ADDENDUM NO. 3

BID TITLE: Indian Trace Roadway Improvements - Surtax-Funded Municipal Transportation
Project No. West 192/193

BID NO: 2024-10

DATE: November 1, 2024

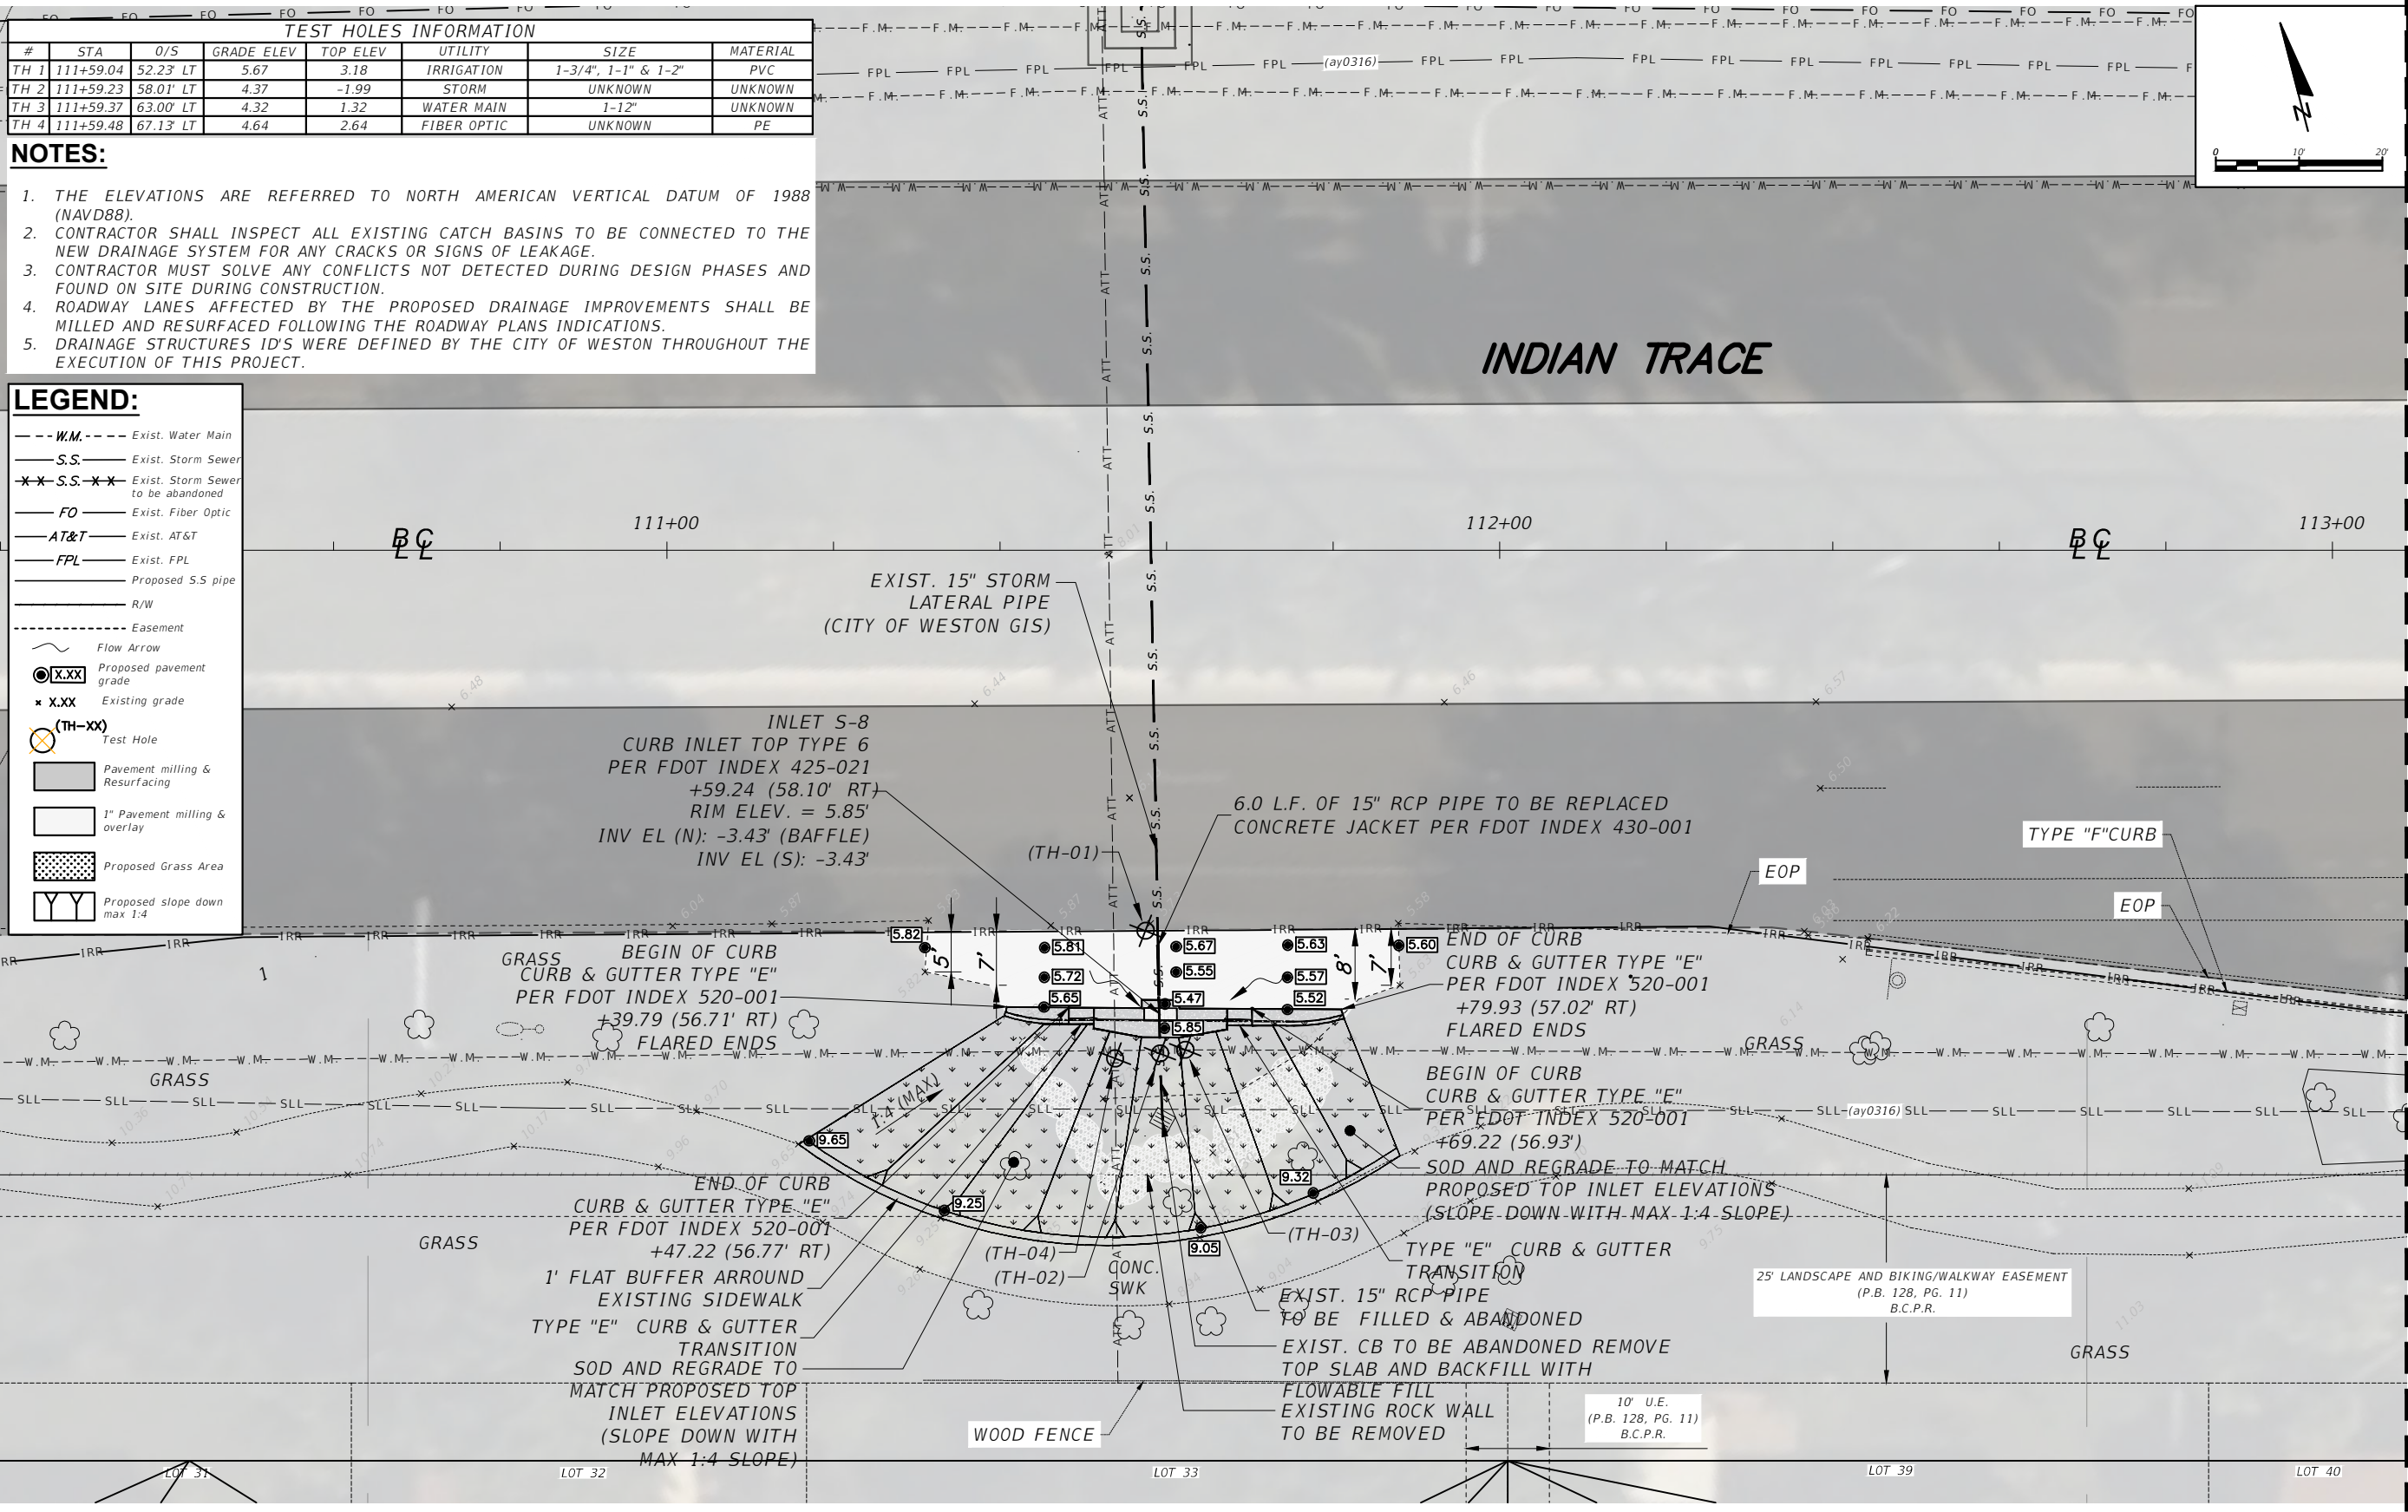
The bid sheet has been modified to reflect the proper pay item and estimated quantity for each pipe size. Additionally, only curb inlet Pay Item 425-1-351 (Type P-5) is needed for the inlets impacted by roadway widening. Pay Items 0425 1 341, 0425 1 361, 0425 1 441, 425 1 451, 425 1 461 have all been deleted. Sheet 02 and Sheet 03 of Drainage Support Task (included) have been reprinted with lighter shading so you can read the text. The cost for the curb inlet at Area 1 S-8 (Type J-6) should be included within Pay Item DST Area 1 that was introduced in Addendum 2. The cost for the curb inlet at Area 2 S-9 (Type P-4) should be included within Pay Item DST Area 2 that was introduced in Addendum 2.
